METROPOLITAN GOVERNMENT OF NASHVILLE AND DAVIDSON COUNTY

STAFF RECOMMENDATION 3715 Princeton Avenue May 20, 2015

Application: New construction-addition
District: Richland-West End Neighborhood Conservation Zoning Overlay
Council District: 24
Map and Parcel Number: 10405016200
Applicant: Preston Quirk
Project Lead: Melissa Baldock, melissa.baldock@nashville.gov

Description of Project: Application is to construct a single-story addition to the rear of the house.

SITE PLAN

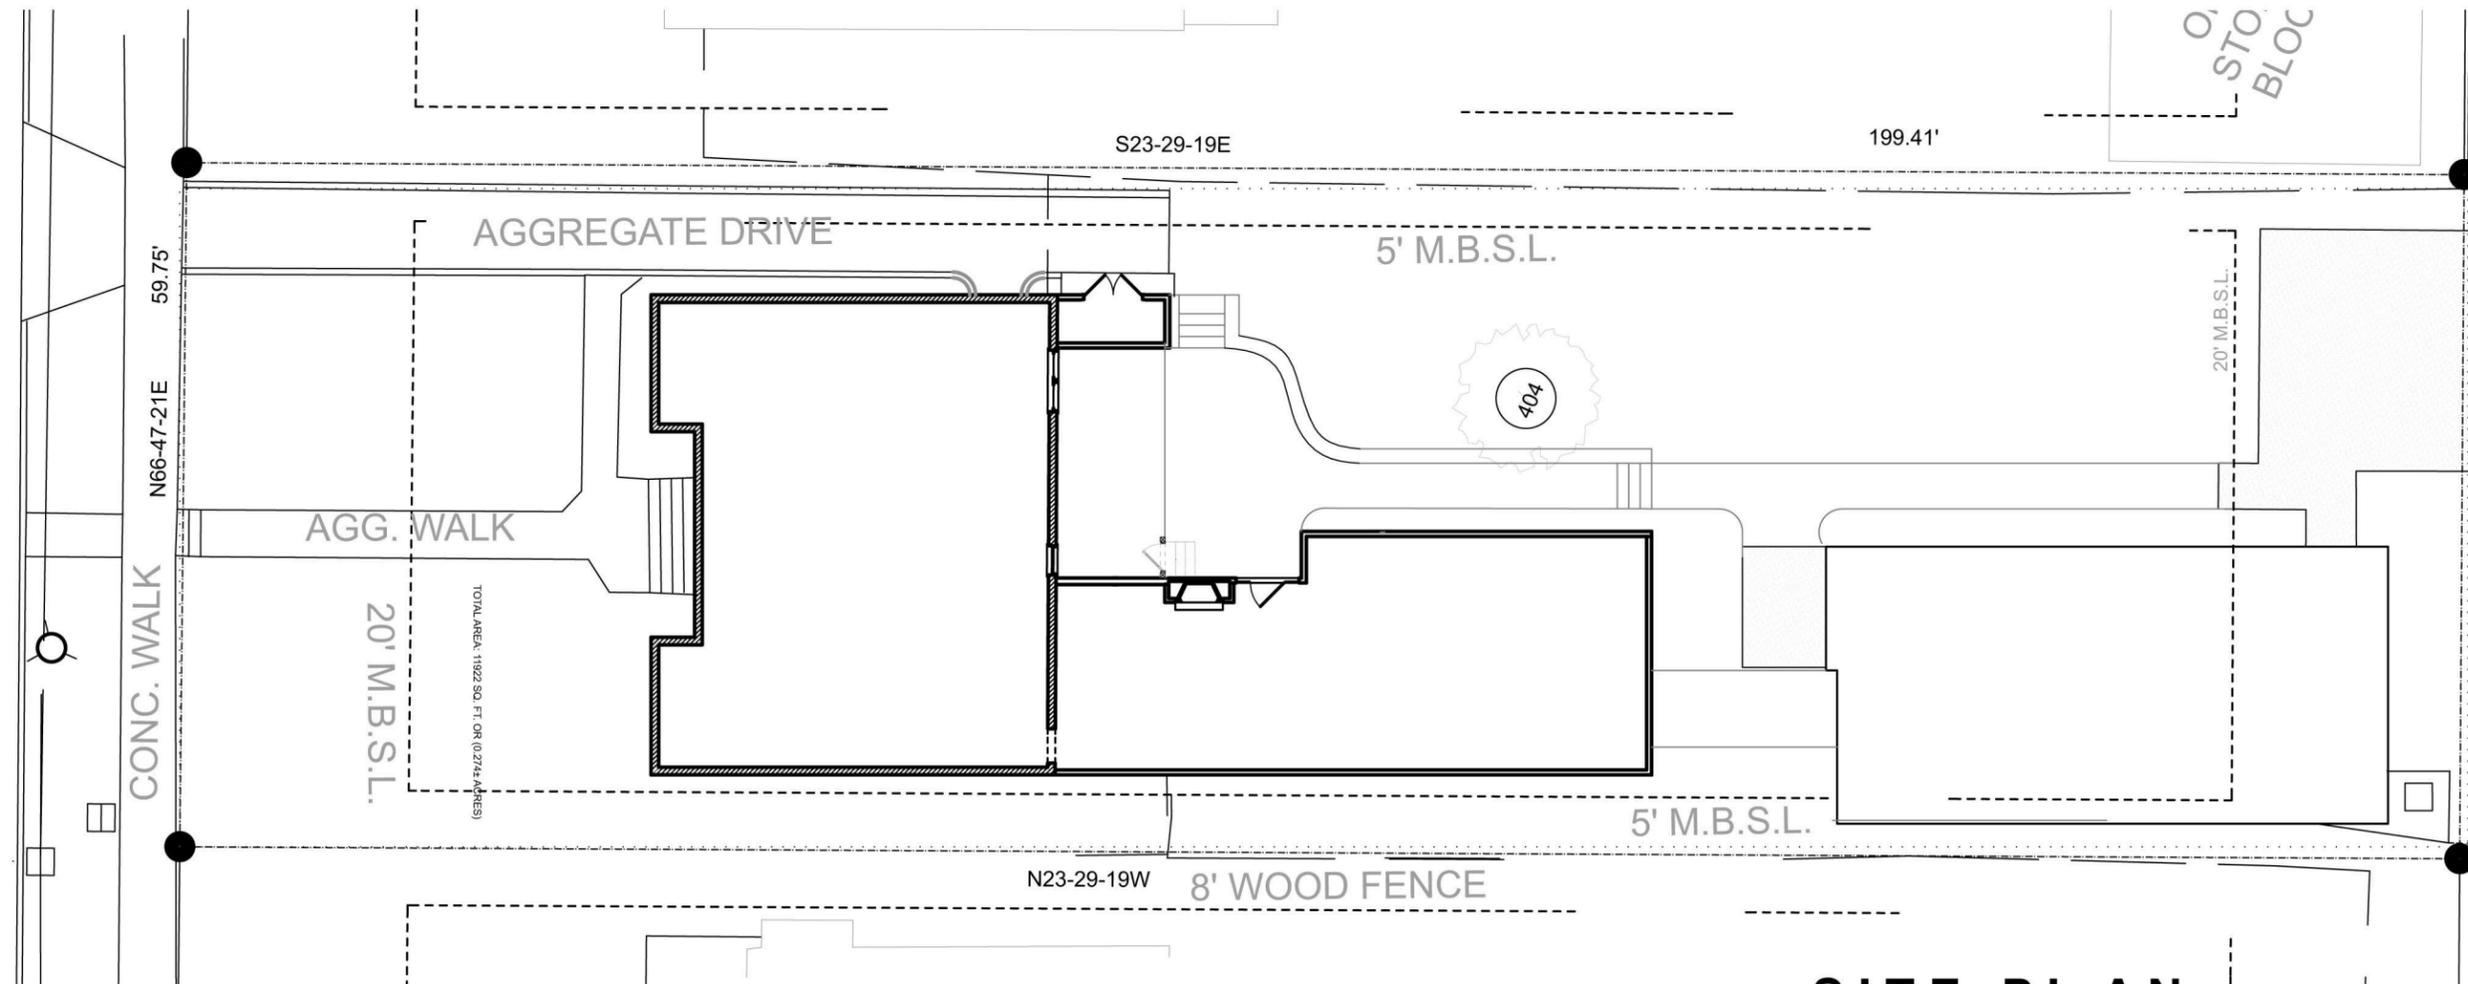
Setback & Rhythm of Spacing: As the addition is proposed to extend straight back from the existing addition and the house, it will be eight feet (8') from the side property line, meeting setback requirements of five feet (5'). It will be approximately seventy-two feet (72') from the rear property line, where the minimum setback requirement is twenty feet (20'). After the construction of the addition, there will be approximately sixteen feet (16') between the back of the addition and the porch of an existing outbuilding (Figure 3). Although staff typically recommends a minimum of twenty feet (20') between primary structures and outbuildings, staff finds the proposed configuration to be acceptable in this instance because both the addition and the outbuilding are less than twenty-four feet (24') wide and a large amount of open space remains on the east side of the property. Staff finds that the addition's setback and rhythm of spacing meet sections II.B.2. and II.B.1.c. of the design guidelines.

Appurtenances & Utilities: A new patio will be paved to the rear of the existing screened porch, with a concrete walkway connecting it to the existing parking pad. No changes to the location of the HVAC or other utilities were noted. If utilities are to be relocated, Staff requests that they be located at the rear or on a side façade, beyond the midpoint of the house, to minimize their visibility from the street.

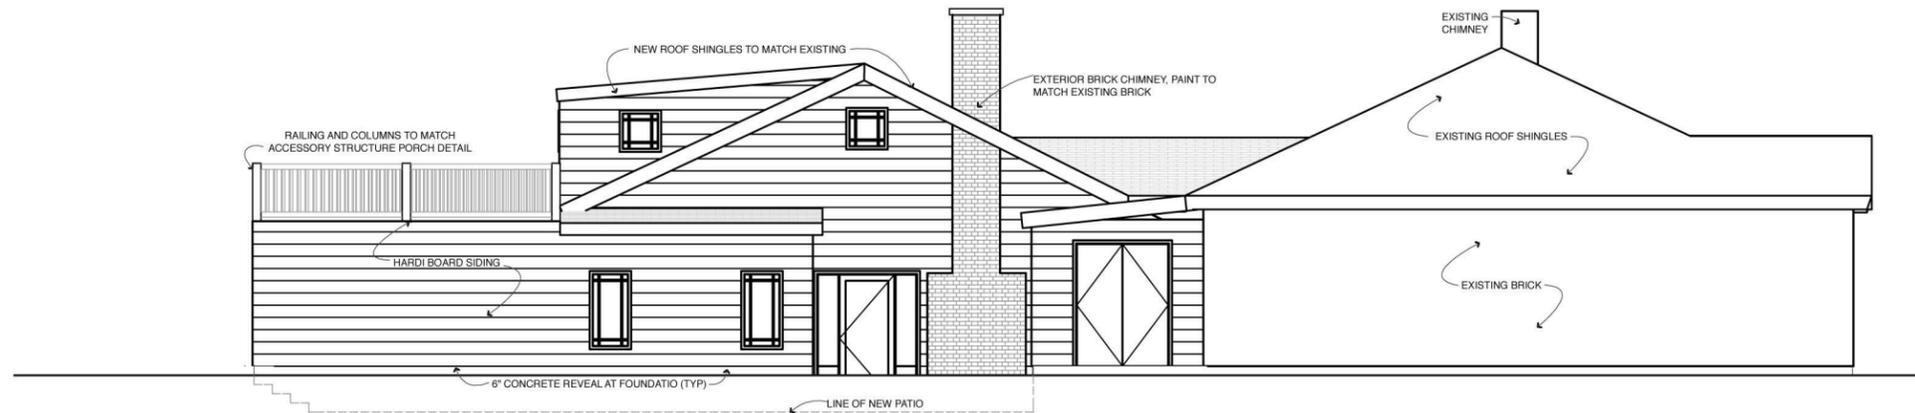
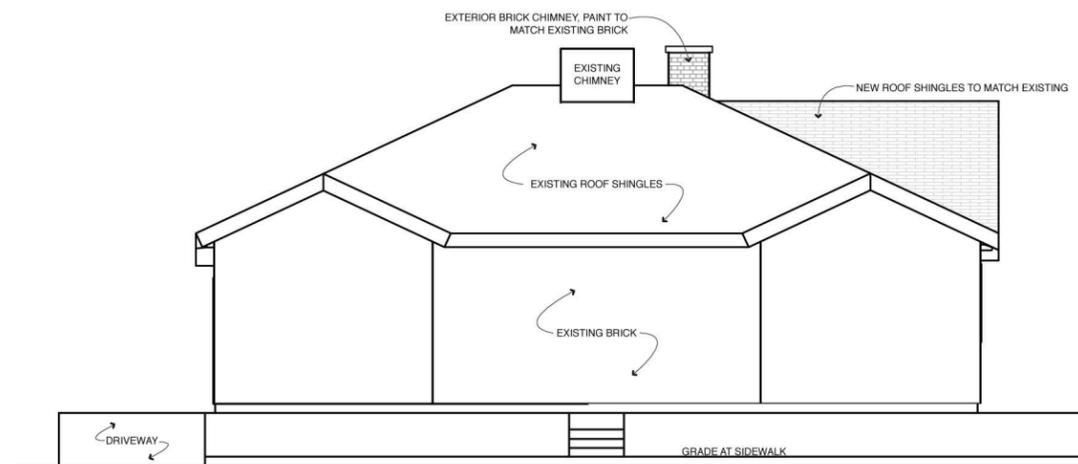
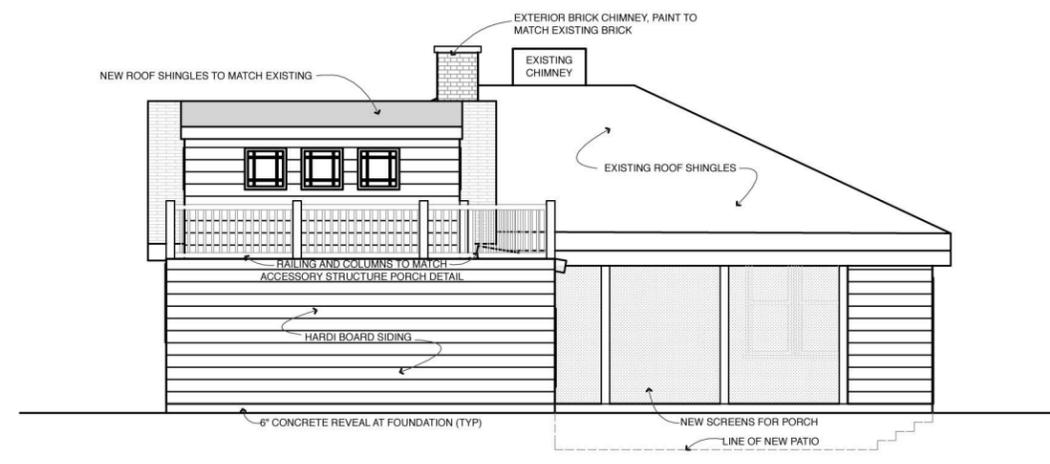
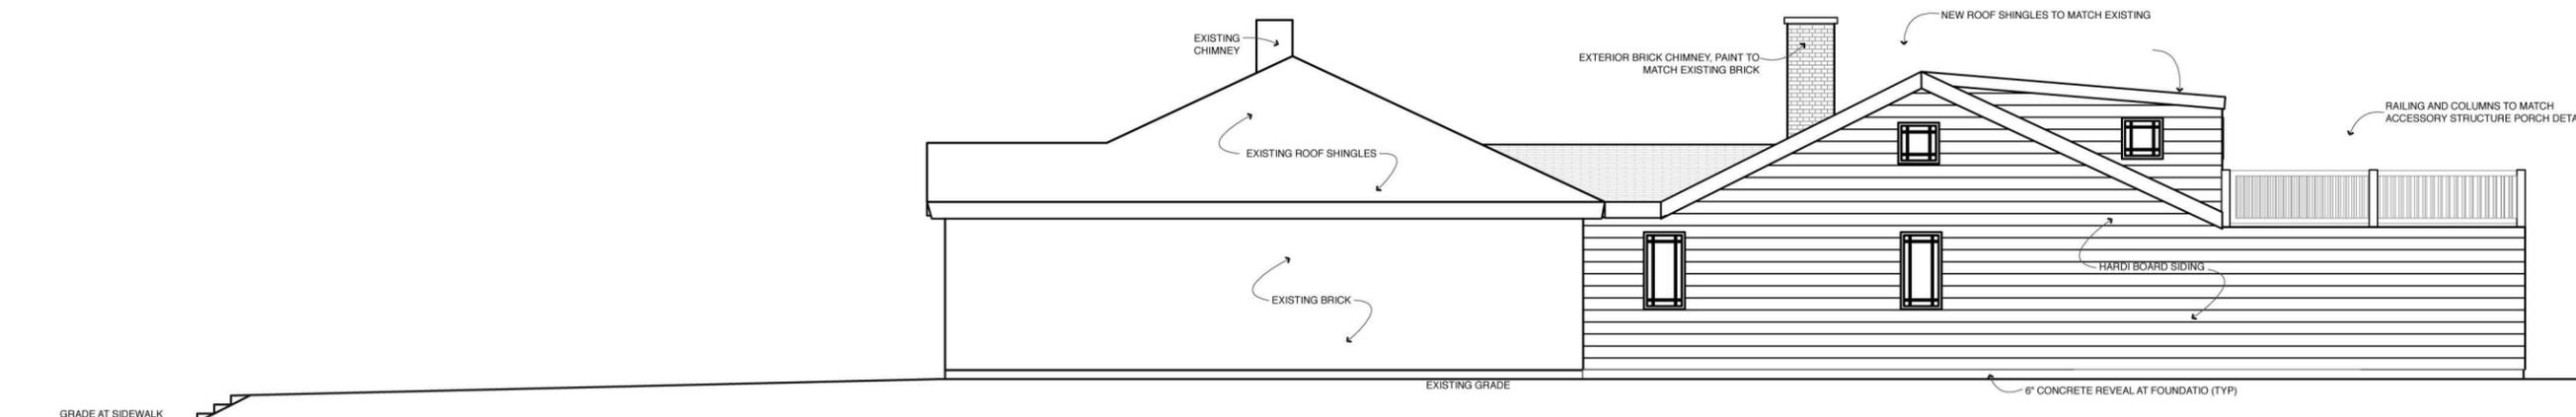
Materials: No changes to the materials of the historic house are indicated on the submitted drawings. The addition will be clad in smooth-face fiber cement siding; Staff requests the siding have a maximum reveal of five inches (5"). The trim will be wood or cement fiberboard. The foundation will be concrete block with six inches (6") revealed. The addition's roof will be shingle and will match the shingles on the historic house. The chimney will be brick painted to match the painted brick on the historic house. The porch will be screened. The materials of the windows and doors were not indicated, and staff will need to approve all windows and doors prior to purchase and installation. The material of the rear second-level deck railing was not indicated, and staff will need to approve that material. With staff approval of the deck railing material and windows and

Roof Form: The addition will have a gabled form with 6/12 pitch. The rear of the addition has a flat roof with a rooftop deck, which is not common, but there are examples of it in this district. The roof form is compatible with the context, and staff finds that it meets Sections II.B.2. and II.B.1.e. of the design guidelines.

Proportion & Rhythm of Openings: No changes to the existing window or door openings of the original house are indicated on the plans. The proposed windows on the addition are generally twice as tall as they are wide, meeting the historic proportion of openings. There are expanses without openings on the west, east, and south elevations of approximately thirty feet (30'), eighteen feet (18') and twenty-one feet (21') respectively. However, visibility of these locations is minimal, as they are located at the back part of the addition. Staff finds that the addition's proportion and rhythm of openings meets Section II.B.1.g. and II.B.2. of the design guidelines.

doors, and the condition that the siding have no more than five inches (5") of reveal, staff finds that the addition meets sections II.B.2. and II.B.1.d. of the design guidelines.
